Review of:

**Dolan & Dean, Consulting Engineers, LLC
Traffic Impact Analysis for
201 Homestead Road
Proposed Warehouse
Block 200.10, Lots 32 & 38
Township of Hillsborough
Somerset County, New Jersey
December 22, 2021**

**Kenneth J. Hausman, PE
NJ License Number: 36155**

Date: October 6, 2022

Figure 1: Daily Truck Trip Generation – Warehousing (Land Use Code 150)

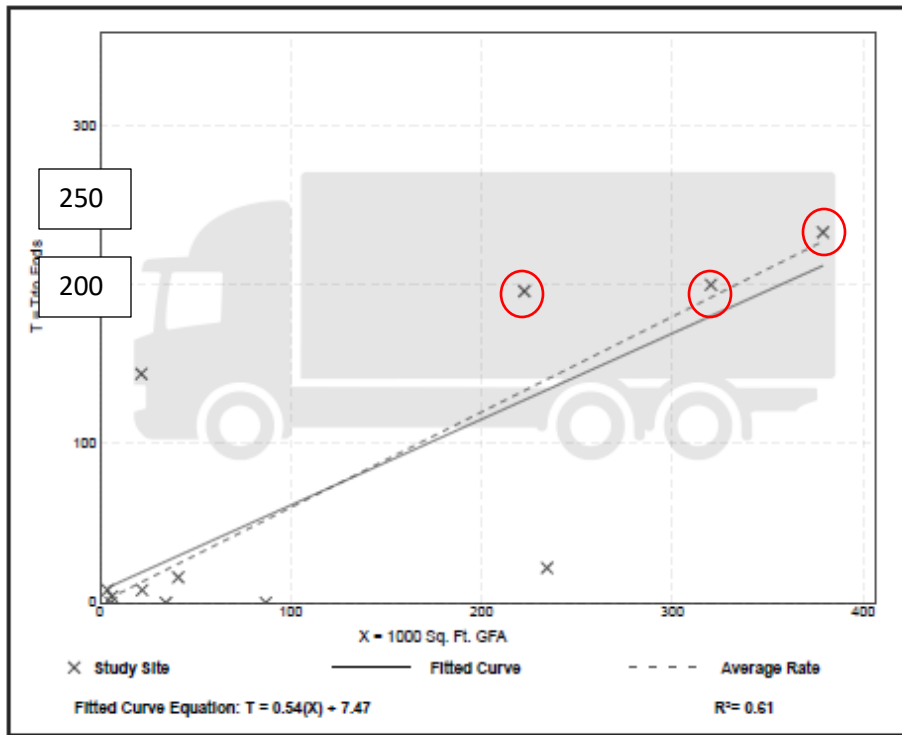
Figure 1 shows the ITE daily truck trip generation rate for warehousing (Land Use Code 150). The proposed developed is two warehouse buildings of 168,304 square feet and 368,995 square feet. As noted in the figure, only four of the twelve sites used in the development of the ITE average rates are greater than 100,000 square feet. A warehouse facility of less than 50,000 square feet serves a totally different function than larger warehouse facilities. ITE recommended practice is that only sites of similar size should be used in the development of average rates and therefore the use of the much smaller sites in Warehousing (Land Use Code 150) is inappropriate. Instead, the Recommended Practice is that a separate trip generation study should be conducted of similar facilities to the proposed development. Specifically, a separate trip generation study is warranted if:

Looking more closely at the ITE Trip Generation graph for Warehousing (Land Use Code 150) reveals the following. For three of the four larger sites, defined as 150,000 to 400,000 square feet, the truck trip generation is relatively constant at 200 to 250 truck trips per day regardless of the size of the facility. If truck trip generation is constant, then it is not a function of warehouse size. Rather, it is likely a function of the warehouse use and the number of loading docks and truck parking spaces provided.

Figure 5: PM Peak Hour Truck Trip Generation – Warehousing (Land Use Code 150)
 Source: ITE Trip Generation Manual, 11th edition

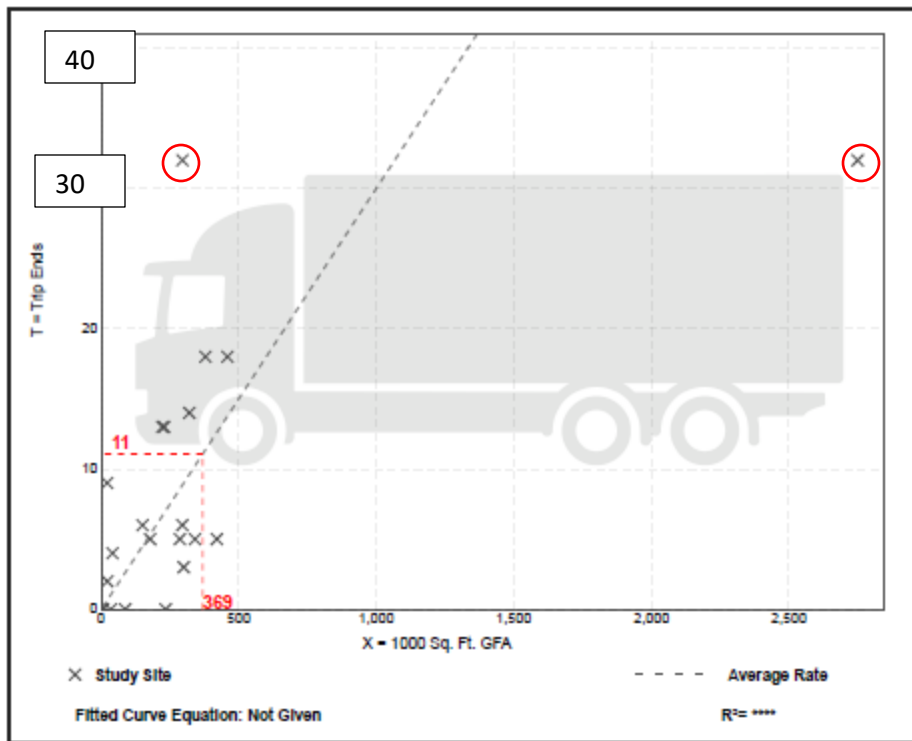
A more refined estimate of the number of daily and hourly trucks can be made once the hours and details of the warehouse operation are provided by the applicant. The computed truck trip generation is much greater than what is presented by the applicant. These additional truck trips will cause much greater traffic impacts than the traffic analysis presented by the applicant. An estimate of 30 to 40 truck trips per hour for warehouses of the proposed size is common. The ITE PM Peak Hour Trip Generation for Warehousing (Land Use 150), presented by the applicant in their Traffic Impact Analysis Appendix and annotated in **Figure 5**, shows:

- Two warehouse sites with 30 to 35 truck trips in the PM peak hour; and
- The goodness-of-fit measure (R^2) could not be computed, indicating that there is no relationship between truck trips and square footage.
